ISSUE: Certificate of Appropriateness for new construction

LOCATION: Old & Historic Alexandria District
802-808 North Washington Street

BAR#2025-00139 & BAR#2025-00202
802 & 808 North Washington Street

NEW RESIDENTIAL BUILDING
 THE WHITLEY, PHASE 2
 808 N. WASHINGTON STREET
 ALEXANDRIA, VIRGINIA
 CERTIFICATE OF APPROPRIATENESS SET -
 B.A.R. HEARING JUNE 18, 2025

Figure 6: Proposed demolition of a portion of the roof at the rear ell

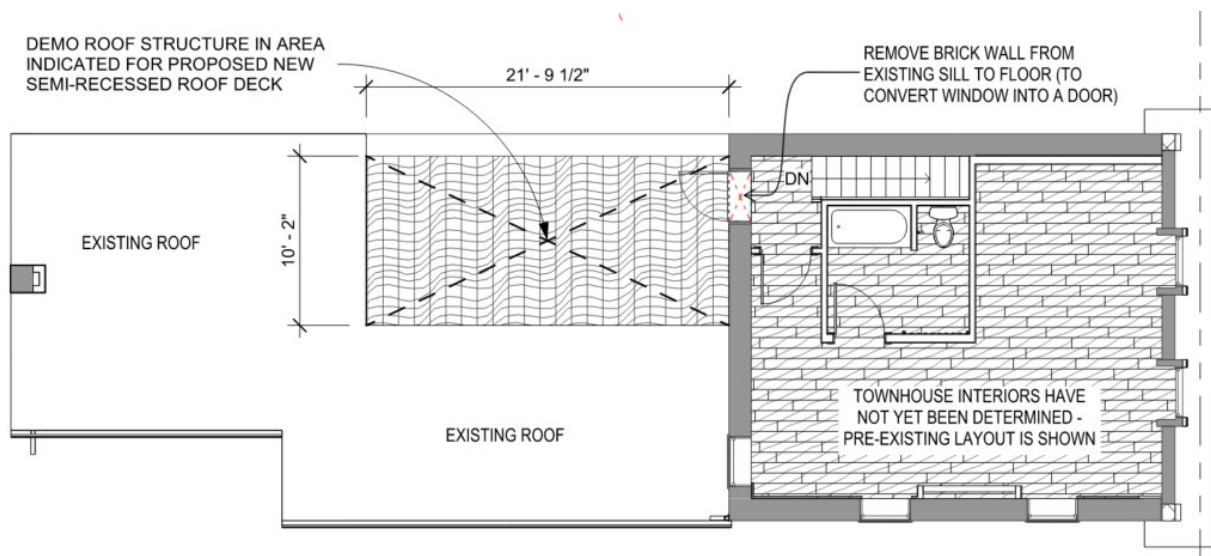
The analysis of the standards indicated above relate only to the portions of the wall areas proposed for demolition/capsulation. The proposed scope of demolition/capsulation is limited to the encapsulation of the north wall of the townhouse and the demolition of approximately 221 square feet of the roof of the existing ell in order to install a roof deck.

The proposed demolition at the roof of the rear ell of the townhome will allow for the construction of a roof deck in the area. The proposal is to demolish a portion of the roof slope and a portion of the exterior wall under an existing window (Figure 6). This will create a flat surface for the roof deck and a new door providing access to the deck. Staff finds that the extent of demolition is minimal and does not include any unique or uncommon design. The proposed demolition will allow for a roof deck that is minimally visible and with little impact on the historic roof form.

Figure 9: Proposed design for the roof deck at the rear ell of the historic townhouse

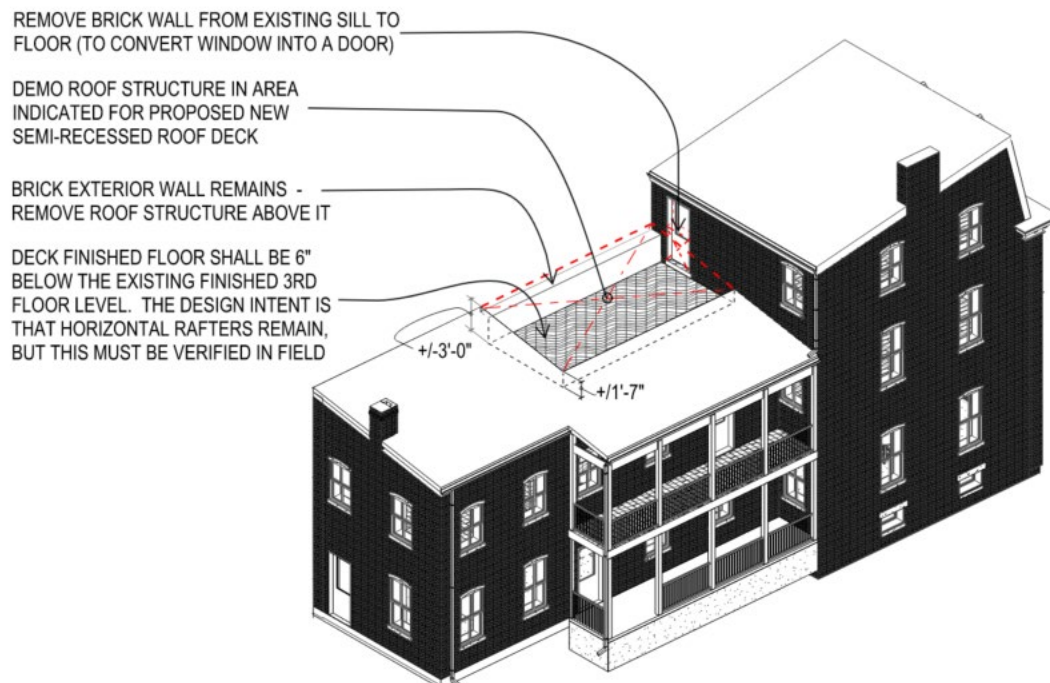
Another building feature that was shown in the Concept Review phase, but with little detail, is the proposed roof deck on top of the rear ell at the historic townhouse. The updated submission now includes details on how this element will be created.

The roof deck will be recessed into the shed roof at the existing ell by removing a portion of the sloping roof area and creating a sunken level area (Figure 9). Access to the roof deck will be through a new exterior door created by enlarging an existing window opening. The perimeter of the roof deck will be enclosed by a glass guard rail. The effect of this configuration is that the roof deck will be unobtrusive when viewed from the street. The *Design Guidelines* state that “Roof decks should be constructed so that they do not interfere with the historic roofline of a building.” Often, roof decks are installed above existing roofs which obscure the historic roofline. In the proposed design, the historic roof line is retained, expressing the original design intent for the rear ell. Staff finds this approach to be less intrusive to the historic architecture of the townhouse.

TOWNHOUSE AXONOMETRIC

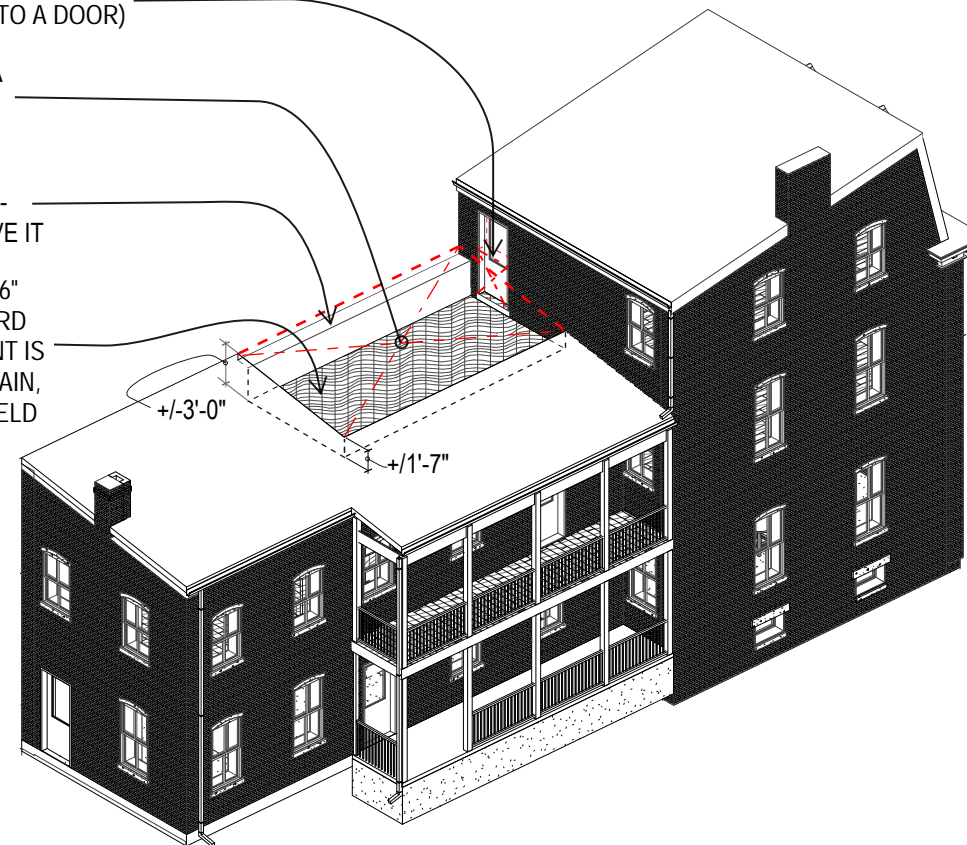
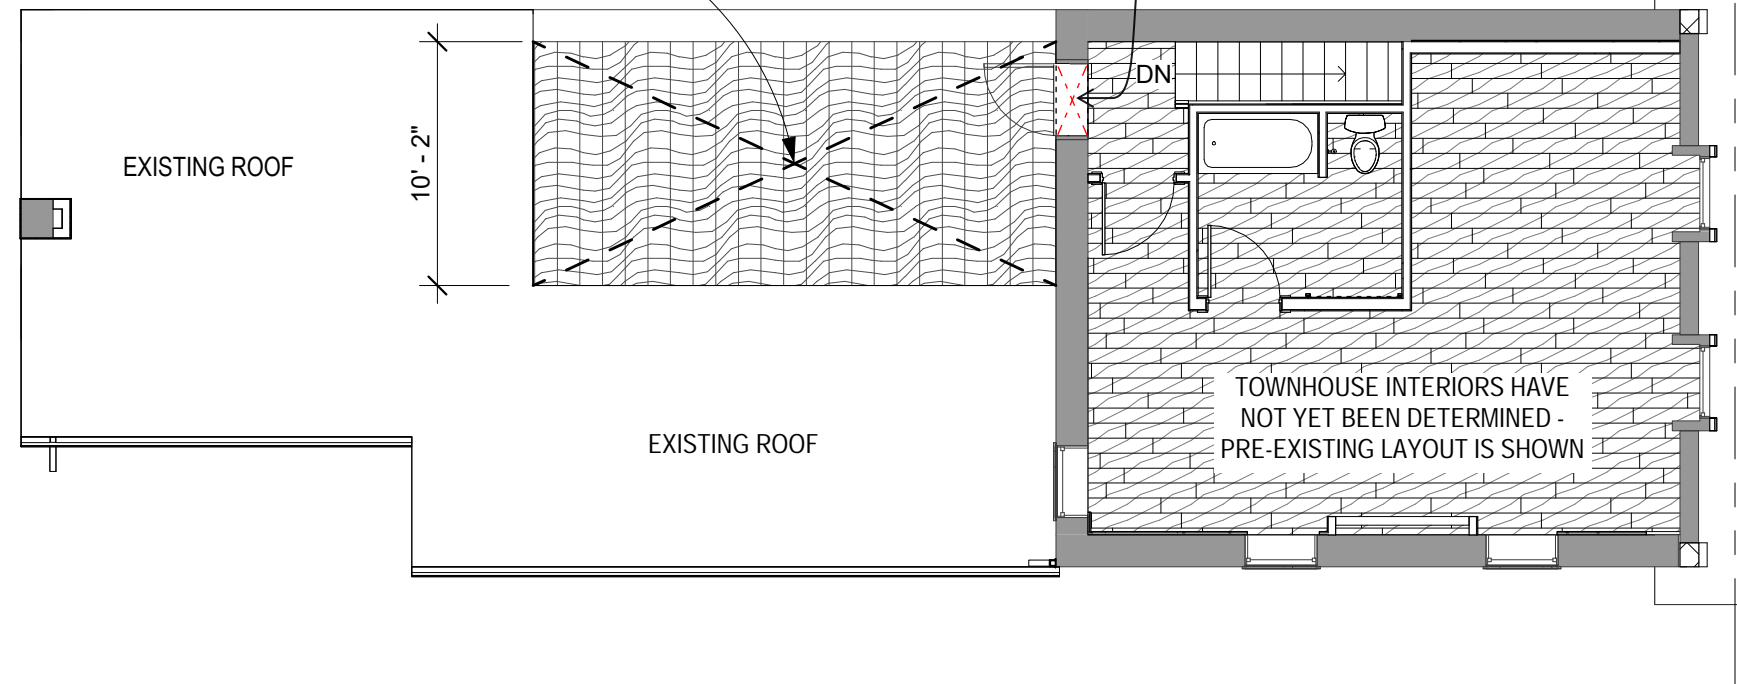
REMOVE BRICK WALL FROM EXISTING SILL TO FLOOR (TO CONVERT WINDOW INTO A DOOR)

DEMO ROOF STRUCTURE IN AREA INDICATED FOR PROPOSED NEW SEMI-RECESSED ROOF DECK

BRICK EXTERIOR WALL REMAINS - REMOVE ROOF STRUCTURE ABOVE IT

DECK FINISHED FLOOR SHALL BE 6" BELOW THE EXISTING FINISHED 3RD FLOOR LEVEL. THE DESIGN INTENT IS THAT HORIZONTAL RAFTERS REMAIN, BUT THIS MUST BE VERIFIED IN FIELD
